Preliminary Acceptance Punchlist
El Paso County – Department of Public Works - Stormwater Section

Project Name:	Upland Flats
EDARP Filing Number(s):	CON2159, SF2112
ESQCP Number:	ESQ2139
Attendees:	DPW SW: Joshua Augustenborg, Erica Rylander, Ben Jones DPW Development Services: Brad Walters Developer: Brett Lewis, Nate Leblanc
Date of Walk-Thru:	10/18/2023
Walk-Thru Number:	1

Photo 19: Finish grouting pipe collar to existing inlet on southwest corner of Akers Drive.

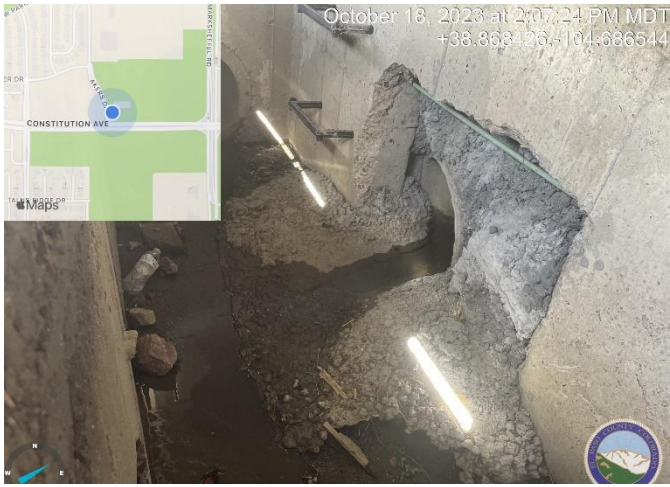
- Remove curb Inlet protection on Marksheffel Road. Reference Photo #9.
- Finish grouting pipe collar to existing inlet on southwest corner of Akers Drive. Reference photo #19.
